Re: Canal Plaza Hotel / Site Plan Submission

TO: Greg Shinberg, Shinberg Consulting
CC: Timothy Hart & Patrick Costin, Canal 5 Studios
FROM: Denise Cameron, PE
DATE: October 22, 2012
RE: City of Portland Planning Board – Response to Revised Preliminary Site Plan Review Comments

CLIENT	Canal 5 Studios		
PROJECT	Canal Plaza Hotel		
DESIGNED BY	MDLM	DATE	10/17/2012
CHECKED BY	DLC	DATE	10/18/2012
PROJECT NO.	222804.17	SHEET NO.	1

SK-3

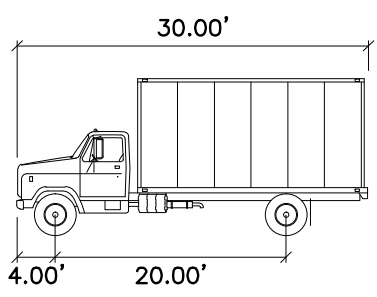
5. *9/5 Comment: The applicant should provide a detailed summary of truck deliveries, including what type of vehicles are expected, and how they will access the rear loading dock. An “auto-turn” analysis should be provided.*

10/2 Status Update: The applicant has provided an auto-turn graphic that illustrates a single-unit truck can access the loading dock. The applicant should provide information on how the truck will begin the “backing” maneuver (will the truck begin backing from Union Street) and provide information if any deliveries will be from a tractor-trailer truck.

Auto-Turn Sketch-3 has been revised to show a single-unit truck will not have to start the backing maneuver on Union Street.
